Memorandum

TO: Columbia River Crossing Task Force
FROM: CRC Pedestrian and Bicycle Advisory Committee (PBAC)
SUBJECT: PBAC Recommendations for World Class Pedestrian and Bicycle Facilities

Purpose of this Memorandum

PBAC Proposed Pedestrian and Bicycle System for Replacement Bridge

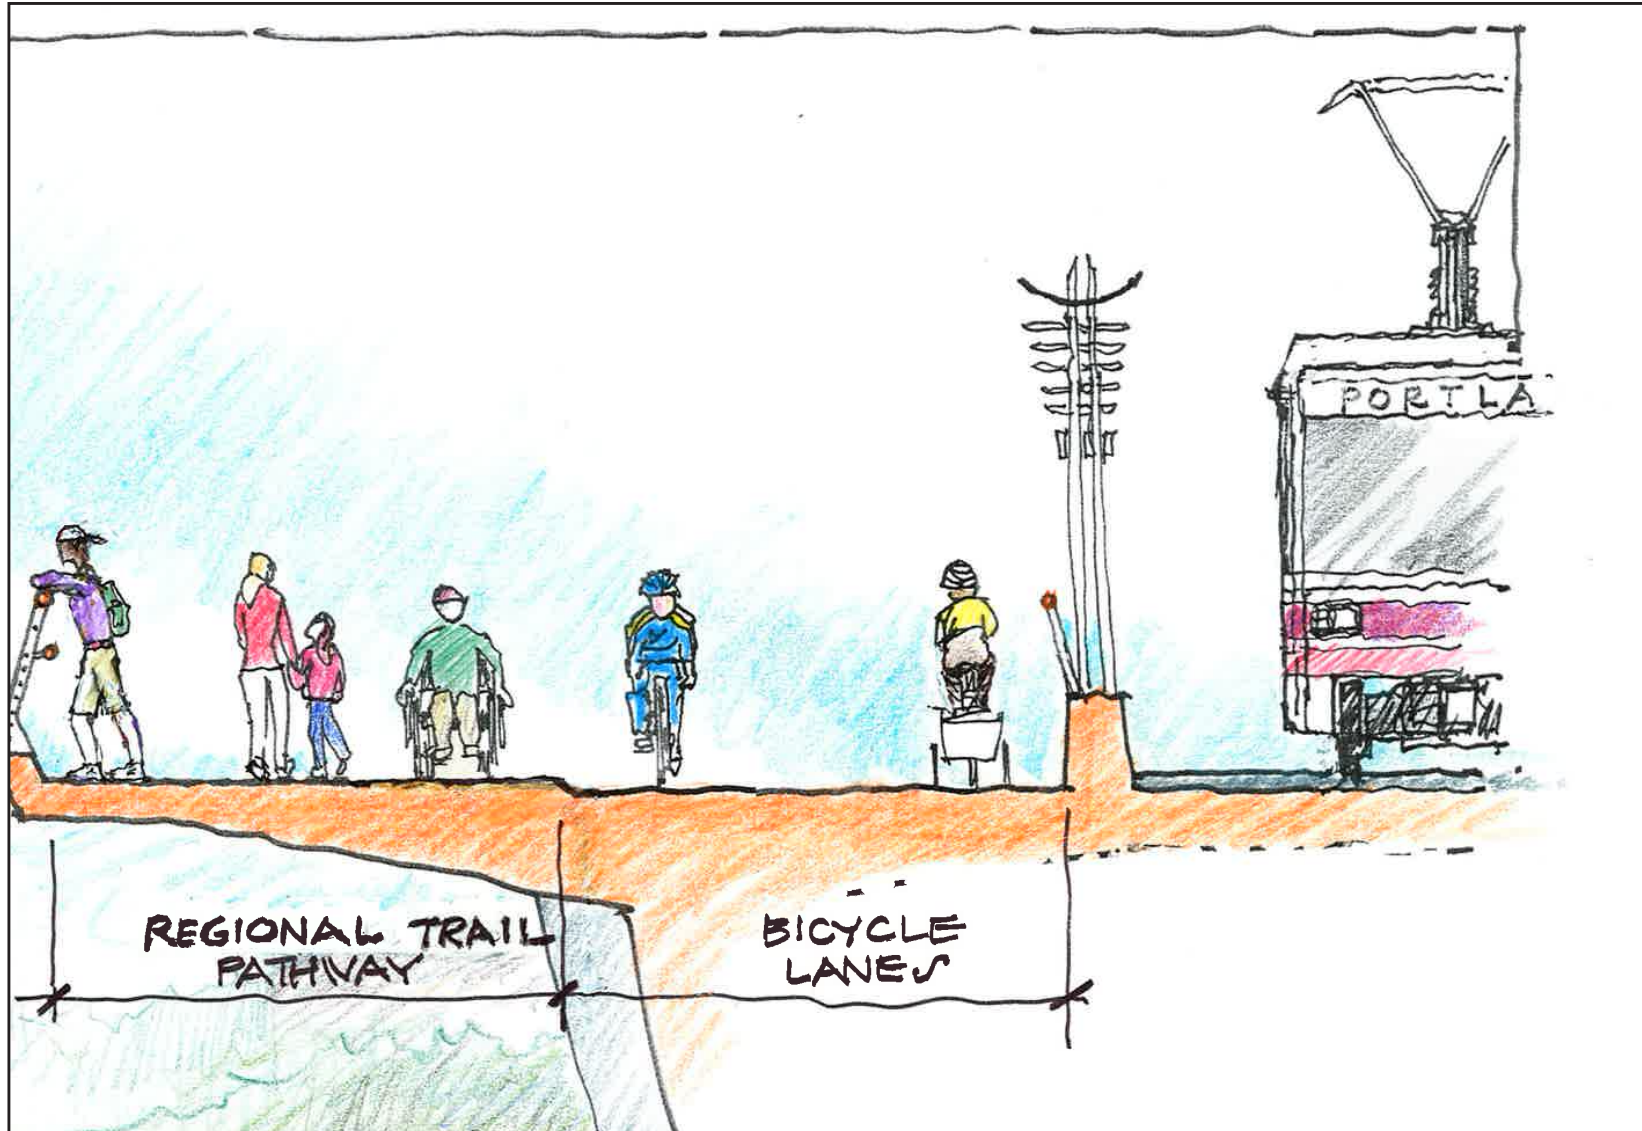
- The overall pathway on the western bridge (adjacent to the transit guideway) must provide separation between recreational users and higher speed bicycle users. To provide this separation, a 12-foot wide regional trail should be provided adjacent to, and to the west of, a pair of six-foot wide bicycle lanes (see attached rendering). These recommended widths are exclusive of potentially needed shy distances, i.e., free and clear of poles and other obstructions to enable safe pedestrian and bicycle movement (a summary of agency standards for multiuse paths, sidewalks and bike lanes is attached).

The regional trail would accommodate pedestrians, persons with disabilities, seniors, families with children, tourists, roller-skaters, and recreational bicycle riders. The adjacent bicycle lanes would be used by bicycle commuters and other faster-moving bicyclists. The regional trail would be at a slightly higher level than the bicycle lanes, but bicyclists in the bicycle lanes would be able to access the trail. Different paving treatments and/or patterns should differentiate the regional trail and the bicycle lanes.
